Access Compliance Report Public Rights-of-Way (Curb Ramps)

Main Street: S_ESPLANADE_ST **Cross Street:** E_PEARL_ST **Location:** NE

ADA ID: RPAT210927133725 **Ramp Type:** Type 4 - Parallel **Initial Pass/Fail:** Fail **Overall Compliance:** No **Severity Score:** 34

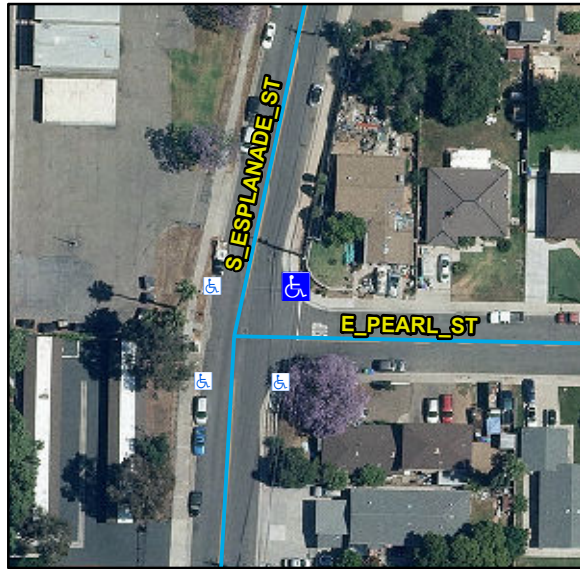
Compliance	Description	Data	Compliance	Description	Data
N/A	Ramp Length LT (in)	72	N/A	Ramp Length RT (in)	115
No	Ramp Width LT (in)	47	Yes	Ramp Width RT (in)	48
Yes	Ramp Run Slope LT (%)	5	No	Ramp Run Slope RT (%)	12.9
Yes	Ramp Cross Slope LT (%)	0.6	Yes	Ramp Cross Slope RT (%)	0.8
N/A	Landing Present	N/A	N/A	DWS Provided	N/A
N/A	Landing Length (in)	N/A	N/A	DWS Contrast	N/A
N/A	Landing Width (in)	N/A	N/A	DWS Length (in)	N/A
N/A	Landing Run Slope (%)	N/A	N/A	DWS Full Width	N/A
N/A	Landing Cross Slope (%)	N/A		DWS Offset Type	N/A
N/A	Landing Movement Obstructed?	N/A	N/A	DWS Offset Left (in)	N/A
	Landing Movement Type	N/A	N/A	DWS Offset Right (in)	N/A
N/A	Landing Shared	N/A			
N/A	Clear Space	Yes			
N/A	Clear Space To Crosswalk (in)	N/A			
N/A	Marked Crosswalk 1	No	N/A	Marked Crosswalk 2	No
	Crossing 1 Direction	W		Crossing 2 Direction	S
N/A	Marked Crosswalk 1 Width (in)	N/A		Marked Crosswalk 2 Width (in)	N/A

Possible Solutions:
Remove & Replace Curb Ramp With Two New Directional Ramps or Equivalent.

OC Std/PROW:
 R304.5.1, R304.3.2, STD 1115
